Bethesda Downtown Design Advisory Panel

PROJECT: 4915 Auburn Avenue
Sketch Plan No. 320180170

DATE: July 25, 2018

RE: Sketch Plan No. 320180170
Preliminary Plan No. 120180210
4915 Auburn Avenue

**FIRE ACCESS ADDENDUM
 EXHIBIT**
 4915 AUBURN AVENUE
 D - 13

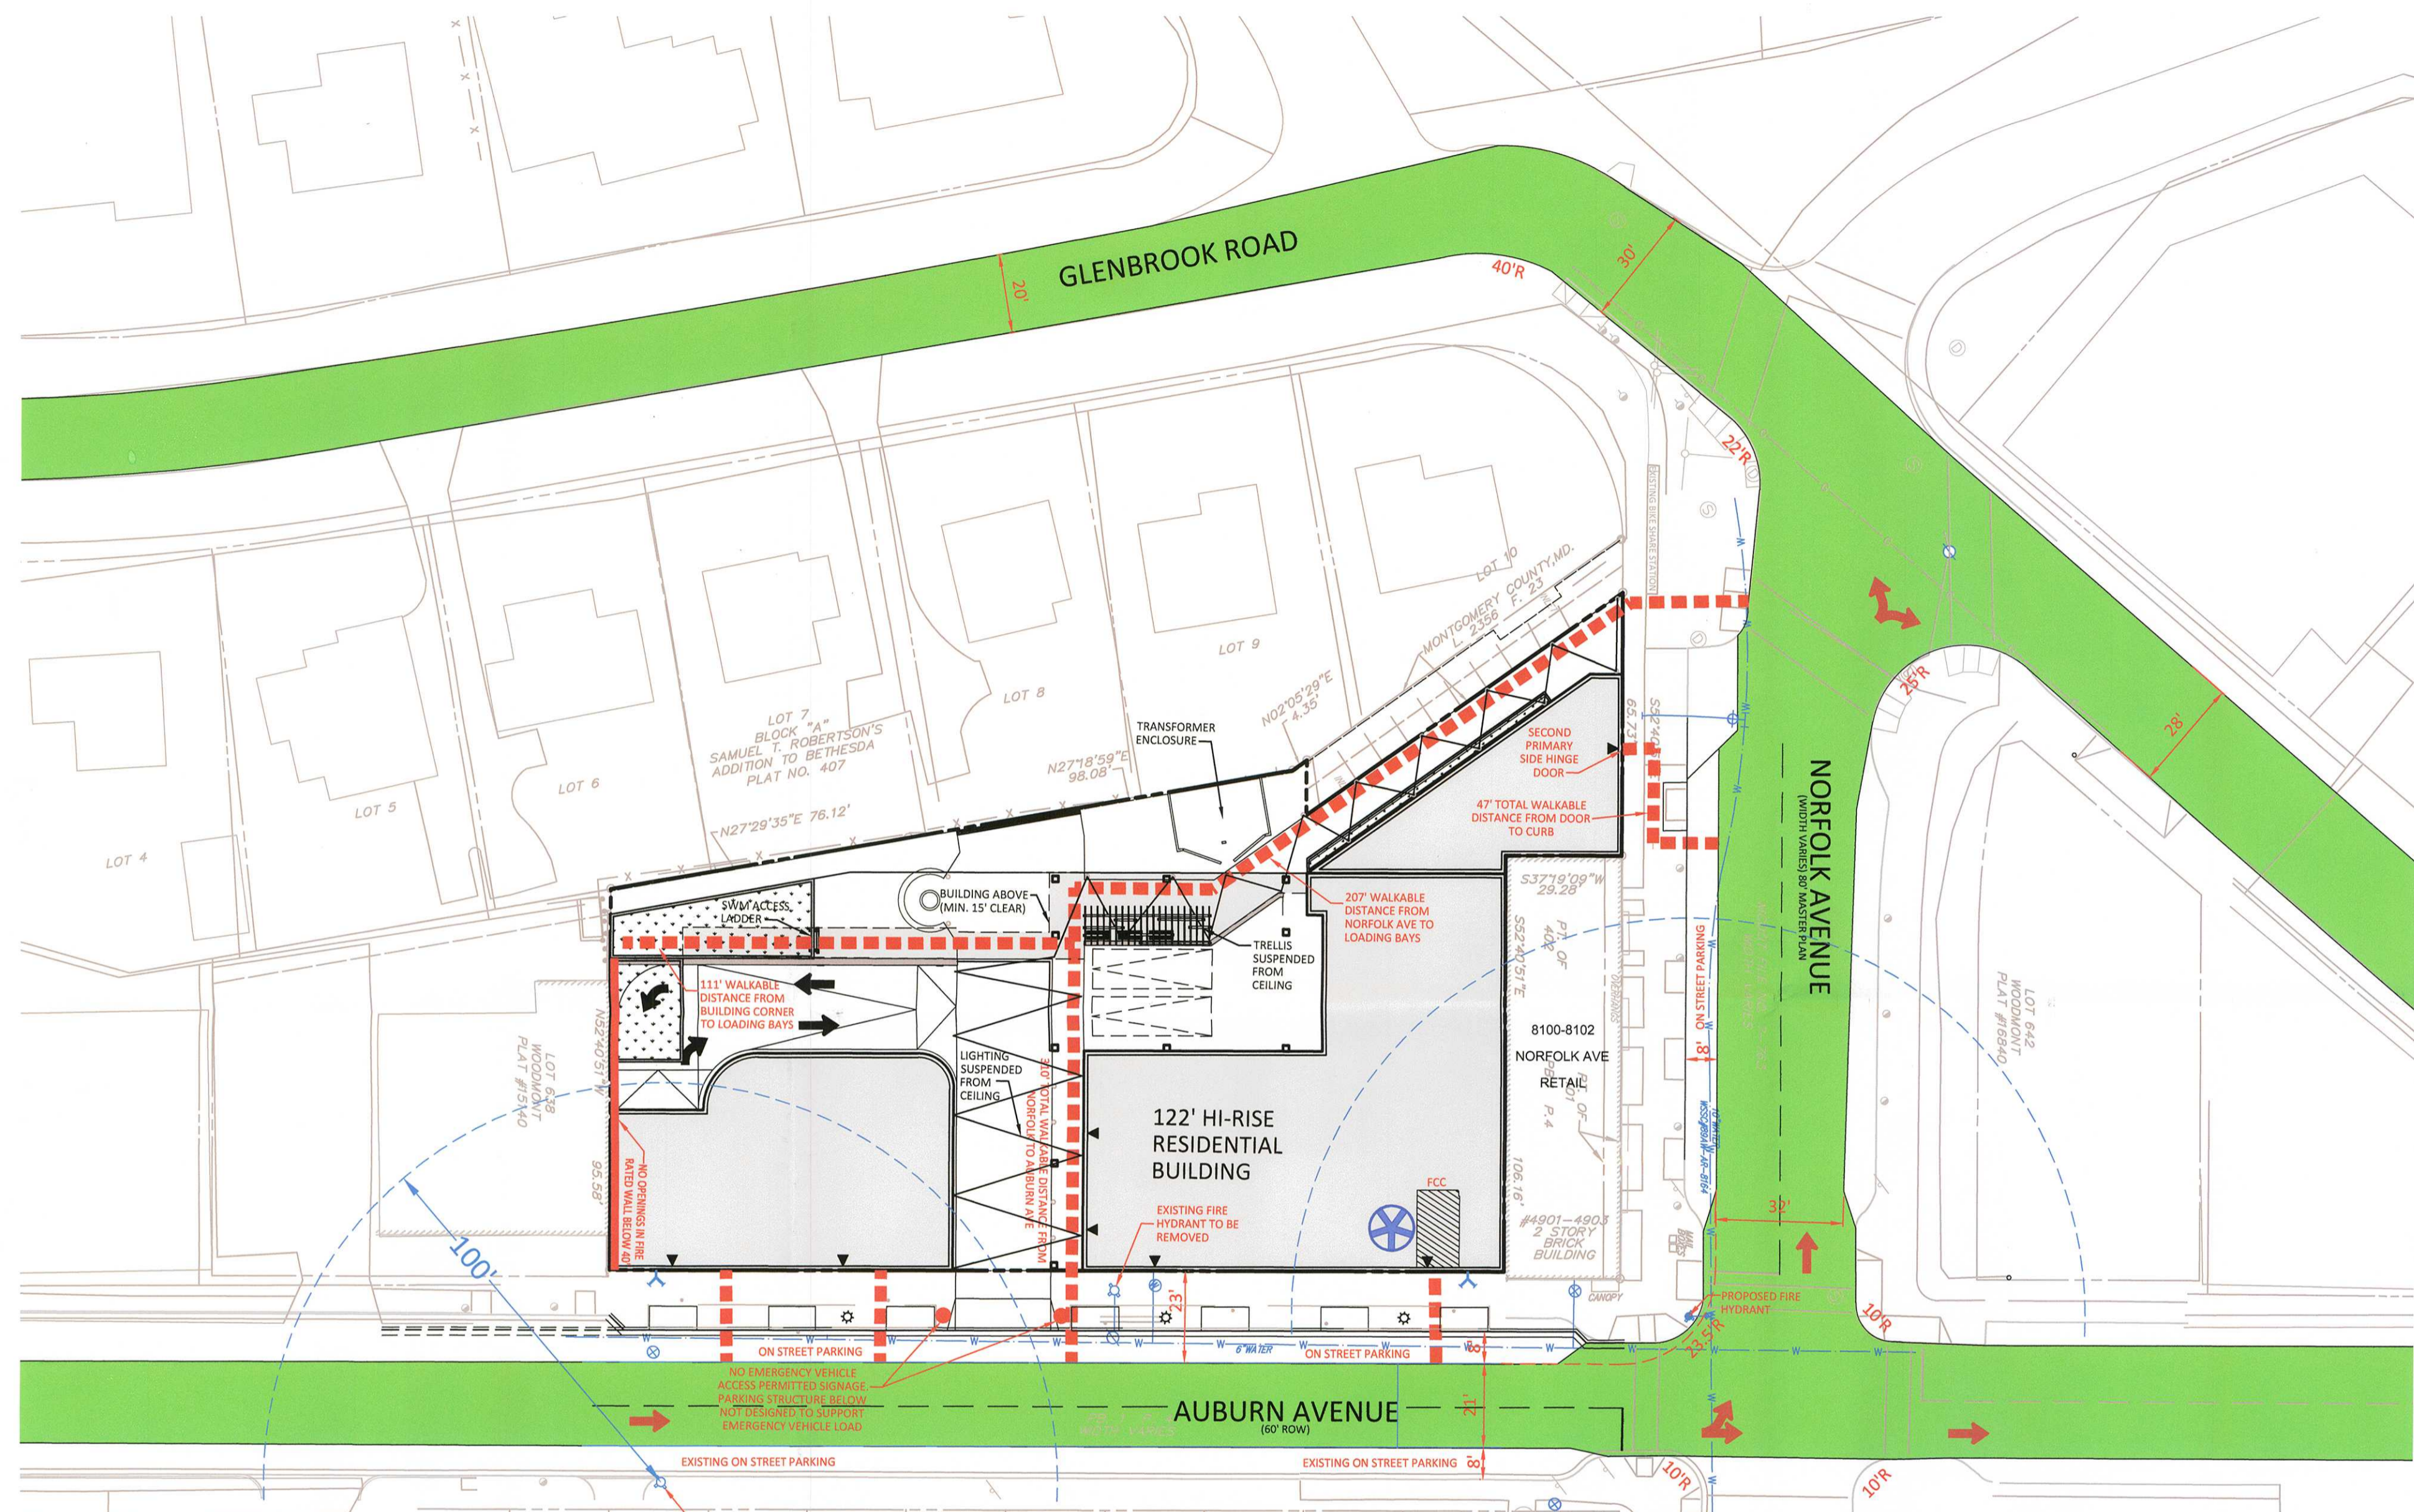
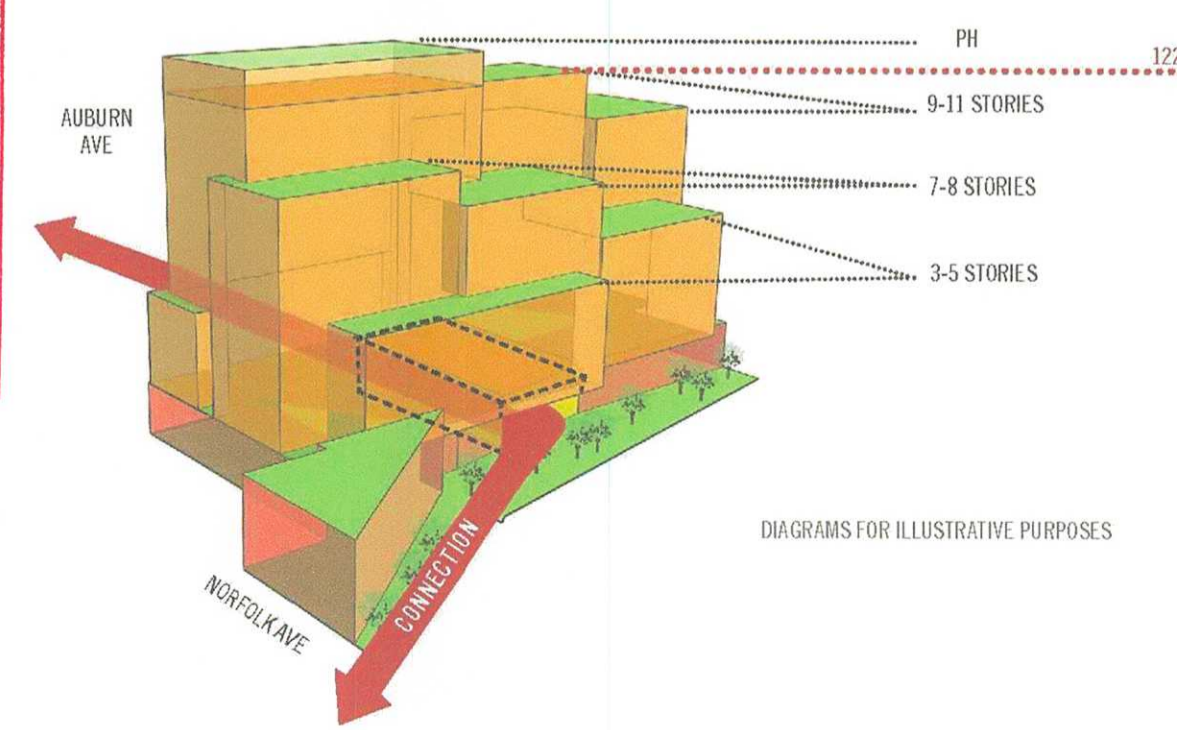
PLAN APPROVED

1. Review based only upon information contained on the plan submitted 26-Jun-18 .Review and approval does not cover unsatisfactory installation resulting from errors, omissions, or failure to clearly indicate conditions on this plan.
2. Correction of unsatisfactory installation will be required upon inspection and service of notice of violation to a party responsible for the property.

FIRE CODE ENFORCEMENT
Fire Department Access Review
Review based only upon information contained on this plan. Does not cover unsatisfactory layout resulting from omissions, errors or failure to clearly indicate conditions on this plan. Correction of such unsatisfactory layout to afford required access will be required if found upon inspection after installation.
6/26/2018
BY: SAC FM: 43 DATE:
